HOLGATE 12 APARTMENTS II

RECOMMENDATION PROPOSAL

1808 12TH AVE. S.
PROJECT # 3018185

DECEMBER 08, 2015

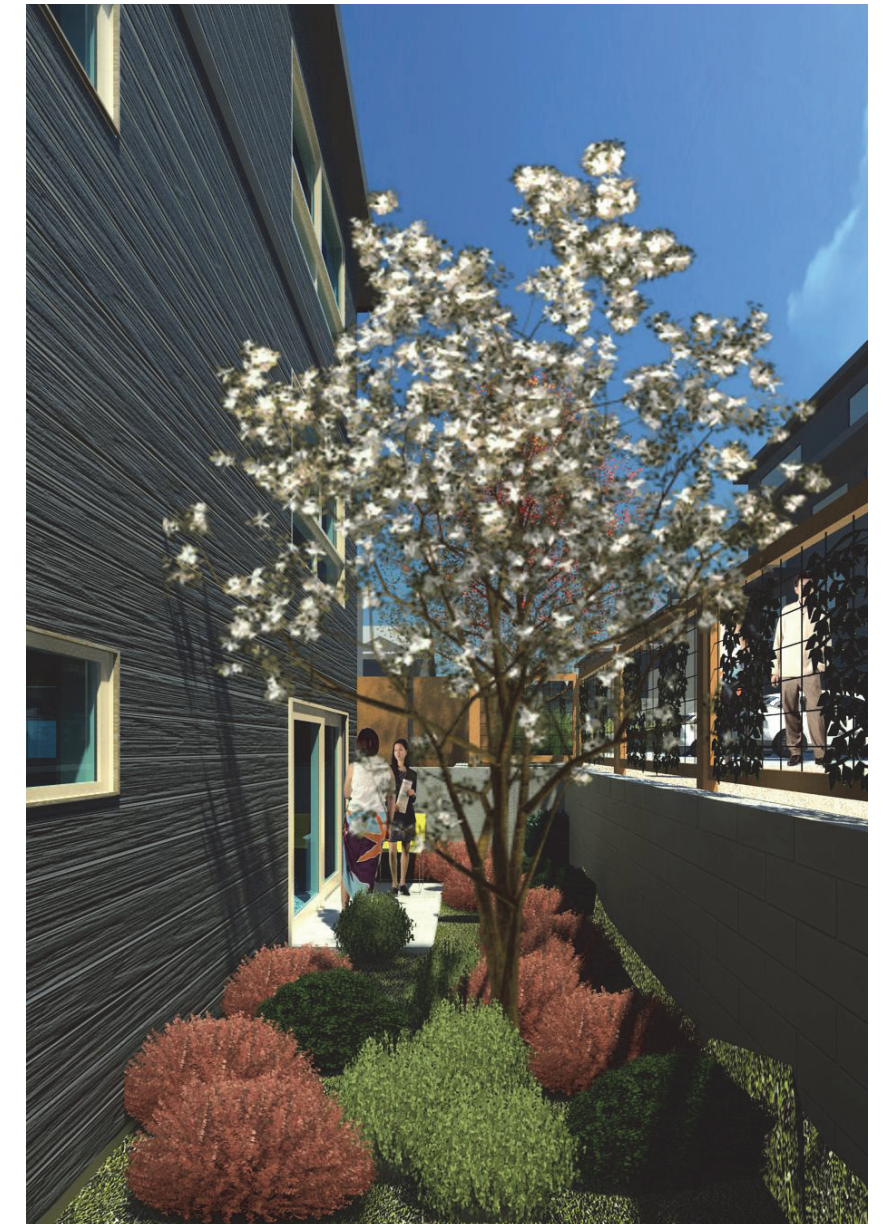
b. The Board approved of the below sidewalk level residential entries. The Board also approved the below alley level residential amenity areas along the alley. (C\$2-B, CS2-C, PL3, DCI-A, DC3-B, DC3-C)

The Alley connection is enhanced by creating planting areas with trees at the Alley level to meet DC3-B3. Patios are created for the ground level units approx. 3'-4' below the alley level to also meet DC3-B to ensure the space has an outdoor use.

West Elevation

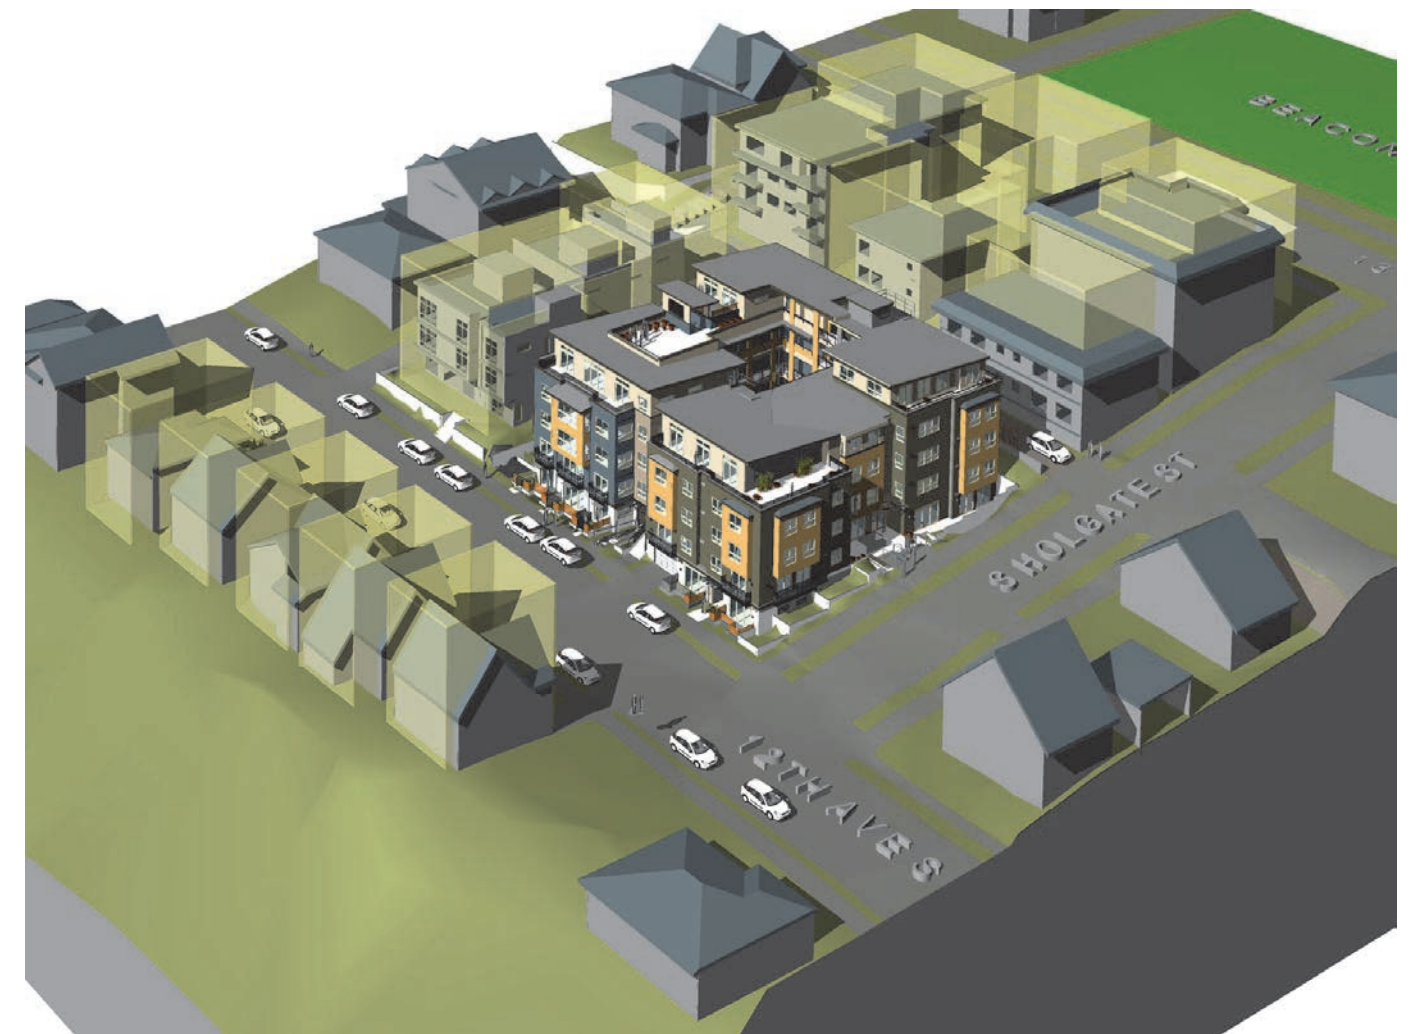
- a. The Board approved of the scale, bulk, and modulation proposed for the building. A strong residential street edge has been created. (CS2-B, DC2-A, DC2-D, DC2-E)

Vertical Modulutions of about 6'-7' wide and 8' deep are proposed on the north and south of the west façade. The City has requested that we also provide documentation of the potential mass that the adjacent sites can achieve that we described in our discussion about how the proposed bulk and scale of the building fits with the existing and potential bulk and scale of the neighborhood.

Common Roof Deck

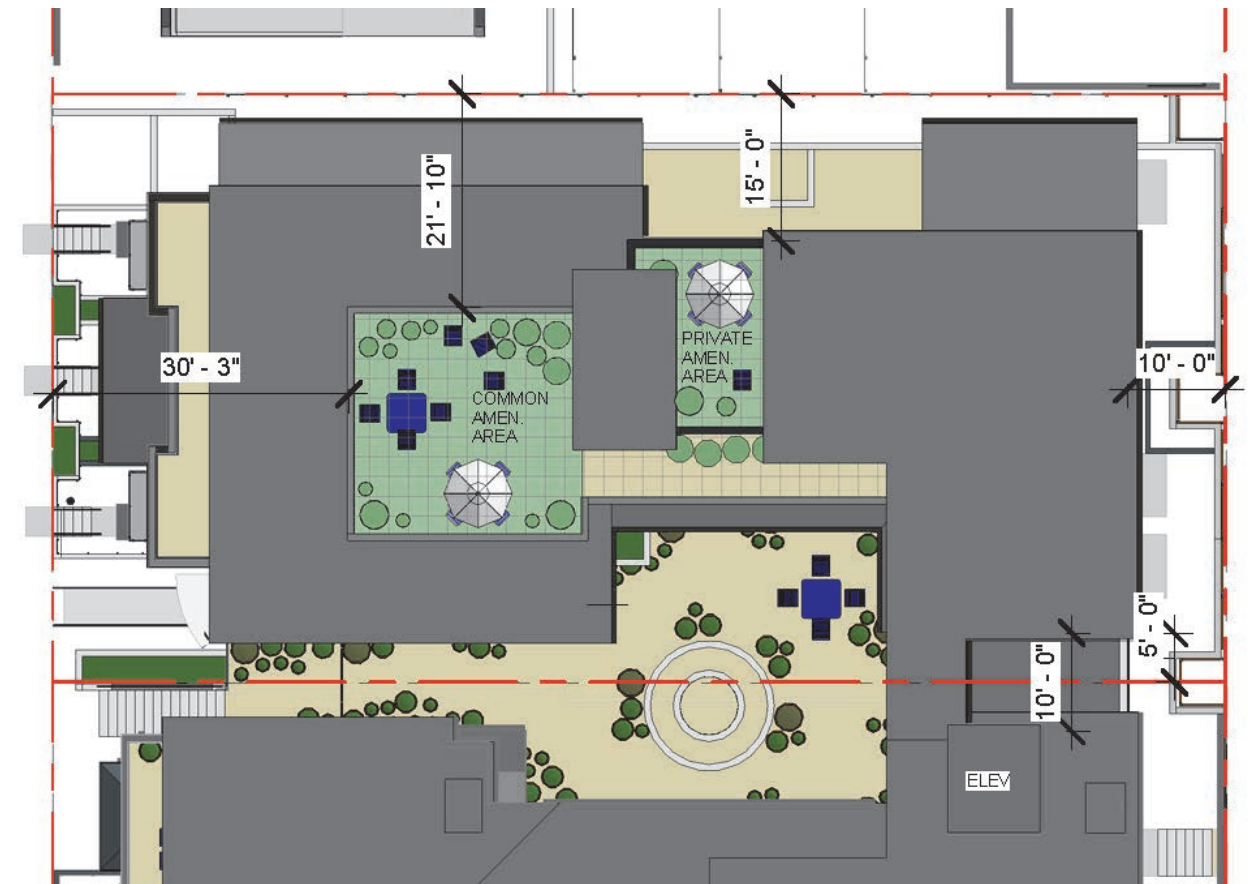
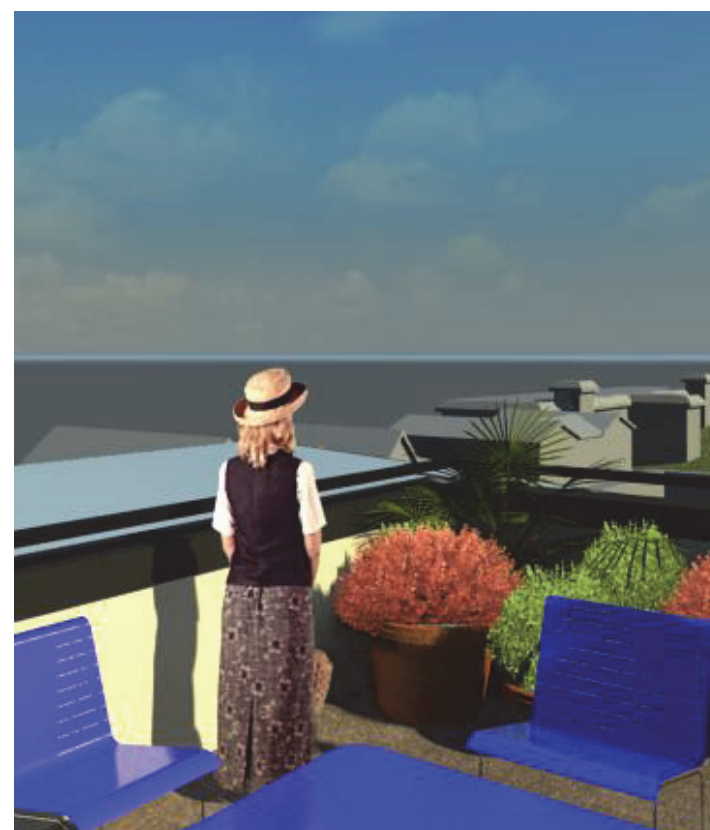
a. The Board approved the rooftop deck and how it reduces the impacts on privacy for the adjacent properties. (PL3, DCI-A, DCI-B, DC2-A, DC3-B, DC3-C, DC4-D)

b. The Board was encouraged by the further development of the rooftop decks. {PL3, DCIA, DCI-B, DC2-A, DC3-B, DC3-C, DC4-D}

The Common Roof Deck has been designed to use the South and East portion of the roof and to set back 30' from the front property line to meet CS2-D5 to minimize disrupting outdoor activity on the adjacent properties.

PROPOSED 33% LANDSCAPED COMMON AMENITY SPACE DEPARTURE WITH GATHERING SPACE

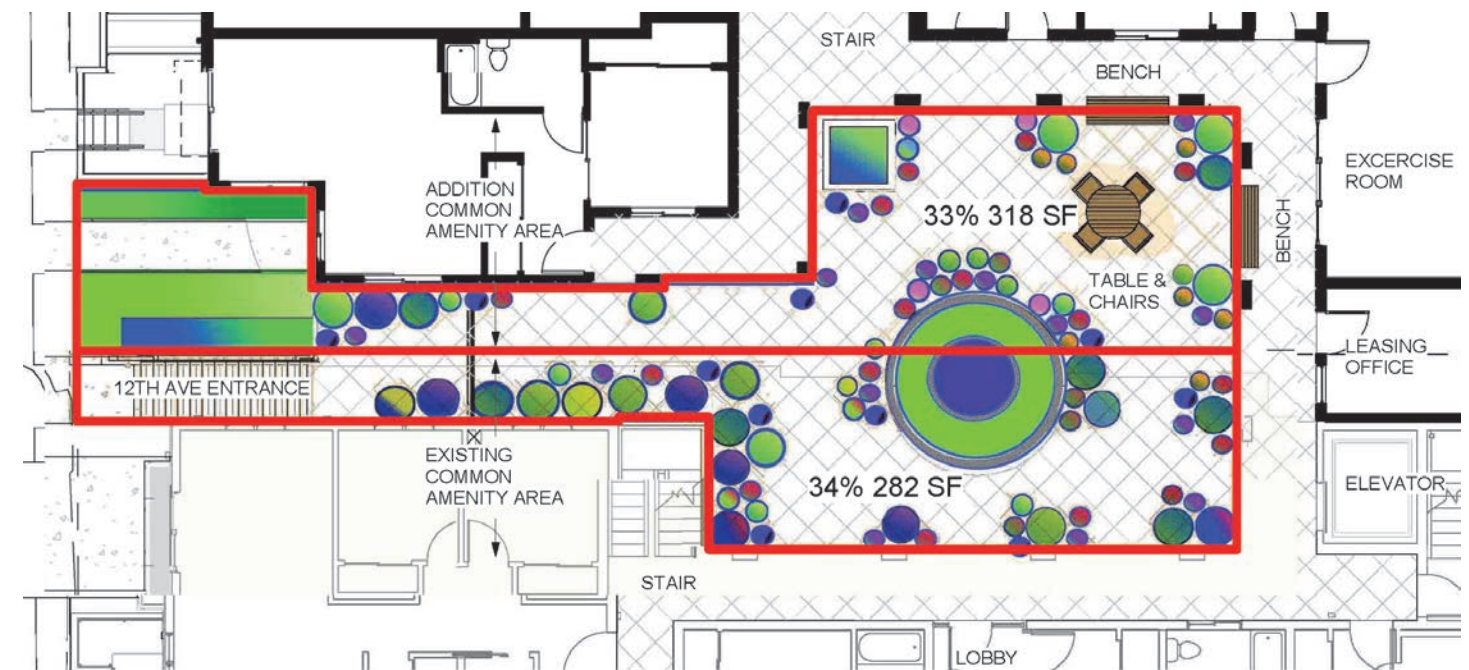
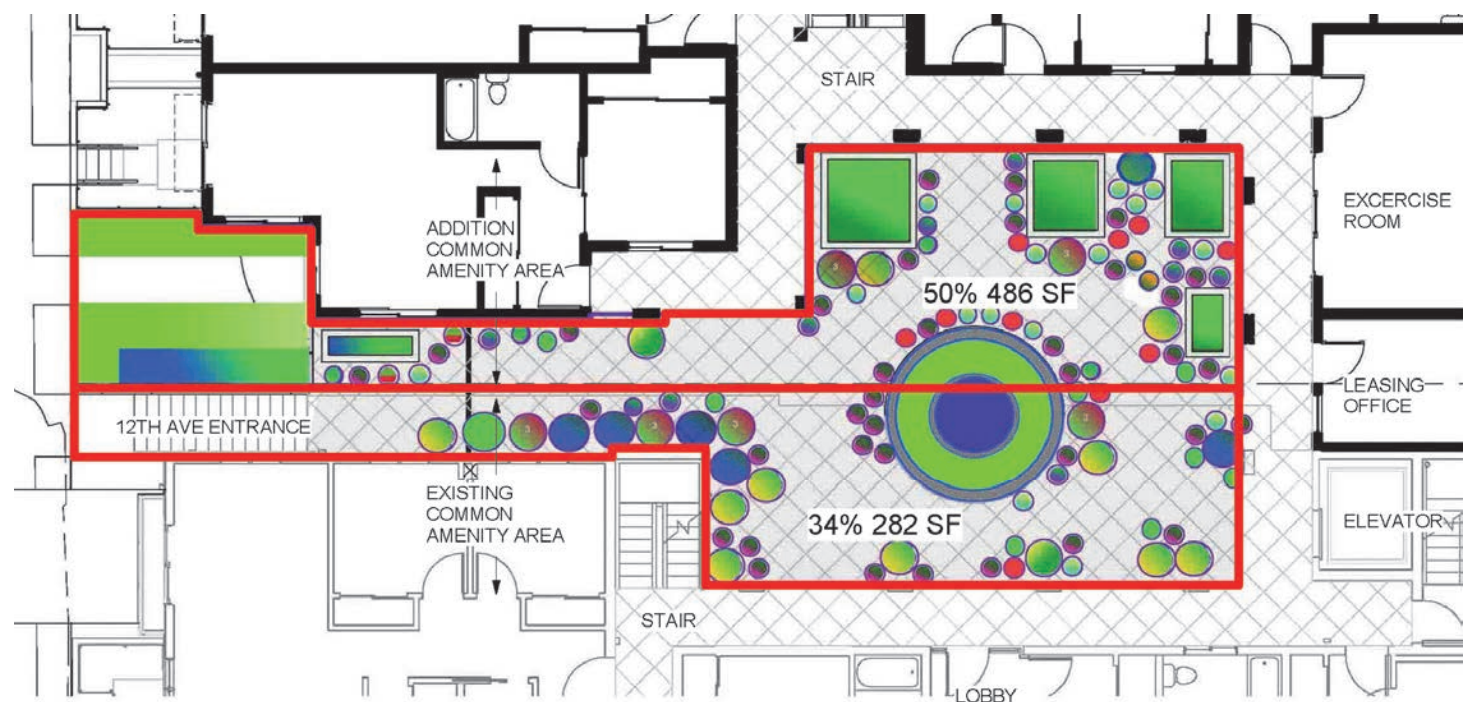
c. The Board has reservations with granting an amenity area departure as proposed. The applicant shall provide calculations and a justification for each building and as a whole for their consideration. {DCI-A, DC3}

The Board wanted to see more detail before approving the landscape departure request specifically the percentage of landscaping on each portion of the project; the existing building (phase I) and the addition.

A departure for the existing courtyard (phase I) was granted to allow it to be landscaped to only 32% to provide space for physical activity and social interaction. The enlarged courtyard will become the main connection from the addition to the existing lobby, which will serve the whole building, the 12th Ave S. entrance which is the path to the bus routes that serve downtown, the existing elevator, which will serve the whole building, the 2 existing stairs that serve the existing building, and the new stair which will serve the addition.

Because of the increased pedestrian traffic the courtyard it will become more important as an outdoor activity area for the combined development to create a gathering place and to encourage physical activity and social interaction to satisfy DC1-A, and DC3 as recommended by the Board.

A work out space is proposed to be located on the east side of the courtyard facing the new enlarged entrance to activate the courtyard. Two benches are also proposed to be located in the sunniest portion of the courtyard and enough space for a table and chairs to help activate the courtyard to satisfy DC1-A and DC3.

We are providing about 344 sf of additional common amenity space for the project. The landscape requirement for this additional space is 172sf.

The proposed landscape area for the provided common amenity area is about 318 sf or about 168 sf less than the required 50% landscaping. This amount is about the same as the additional landscaping required for the additional Common Amenity area that we are providing.

If we are required to provide 50% landscaping the courtyard will be reduced to a few pathways to connect the main lobby, the 12th Ave entrance, the elevator, and the 3 stairs. There will have to be additional concrete raised planters added and there will be no space for benches or table and chairs. This will result in an open space not able to provide for a gathering space, physical activity, social interaction and not satisfying DC1-A and DC3.

LIMITED VIEW OF TOP OF OLYMPICS IS ABOUT 50% BLOCKED BY 5TH FLOOR OF ADDITION

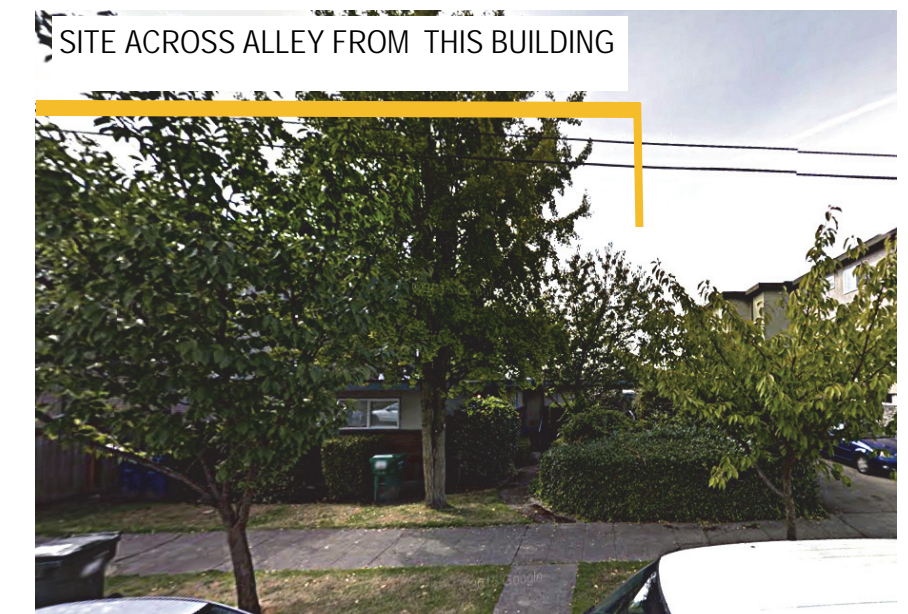
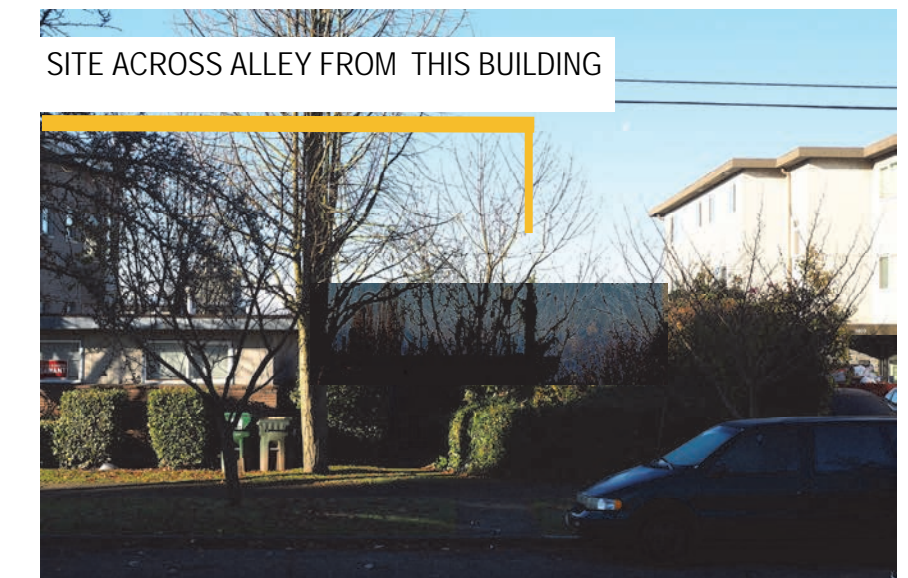
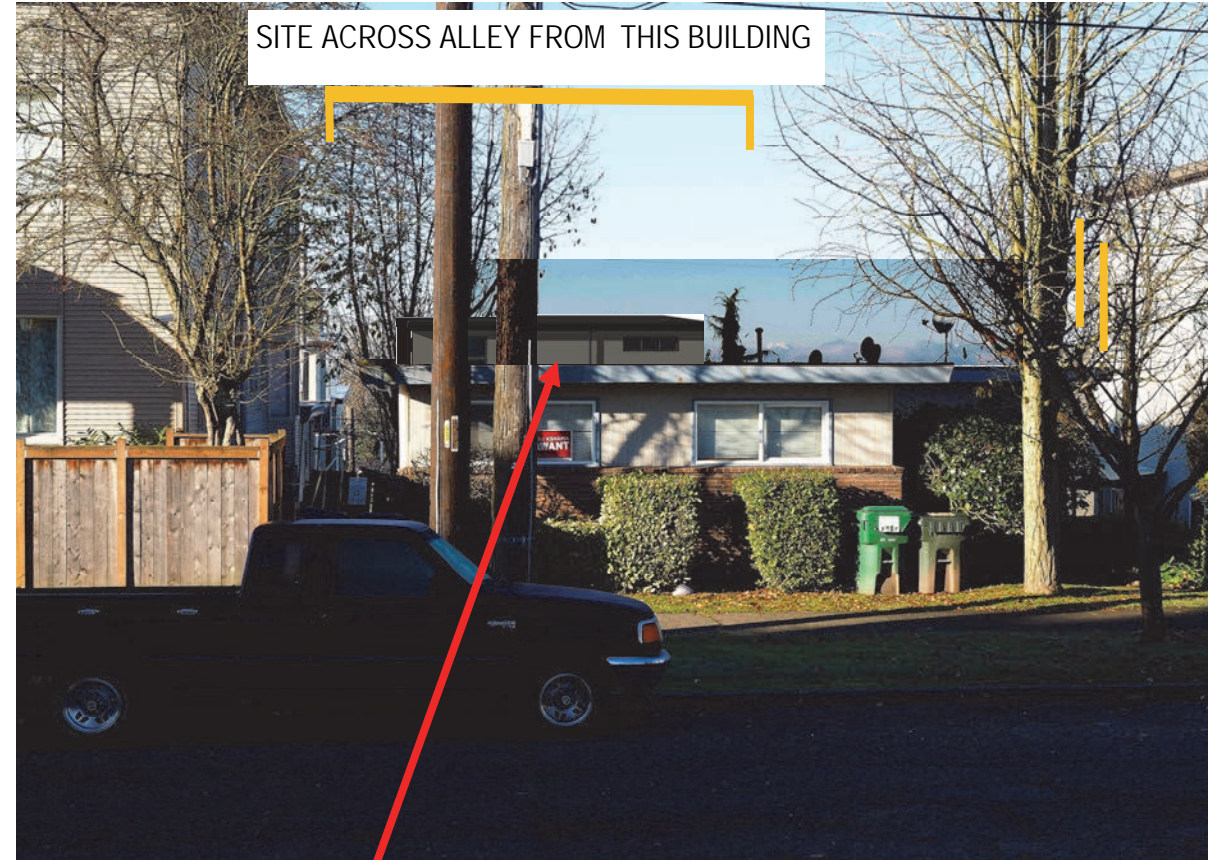
The City has also requested that we address a concern for potential view blockage from the Park.

The area of Beacon Hill Playground that is directly east of the site, on the other side of 13th Ave S. are the tennis courts which have a chain link fence along the park boundary. The shots in the fall were taken just outside the fence at the level of the tennis court which is about 4' higher than at sidewalk. The view from the sidewalk would be much more limited.

From the playground someone would have to view through the fence while using the tennis courts and look over the building at 1807 13th Ave S. and through the vegetation both on 13th Ave S., the site at 1807, and the vegetation in the greenbelt on the other side of 12th Ave S. to see a view of the Olympics. There is a much less obstructed view of the Olympics about 80 feet to the south of the tennis courts at S. Holgate St.

The view of the Olympics from the tennis courts directly east of the site are mostly blocked by the existing one story apartment building and landscaping and the trees in the greenbelt across 12th Ave S. in the spring and summer except for one place at the very south end of the tennis court where the view is diagonally across the site. In the fall and winter the view is also blocked by the building and obscured by the branches of the trees mentioned above except for the same place at the south end of the tennis court.

The proposed building will be about a story taller than the flat roof of the existing apartment building and so will reduce the view of the mountains by about 50% from the one place in the south end of the tennis courts where the view is not blocked or obscured by the trees and the existing one story apartment building.

It is our understanding that the site was recently purchased for re-development. The zoning is LR3 which allows a 43' to 45' high building. We expect that the new development will be at least 3 stories high and block the very limited view of the tops of the Olympics from the one place in the tennis courts where it exists now.
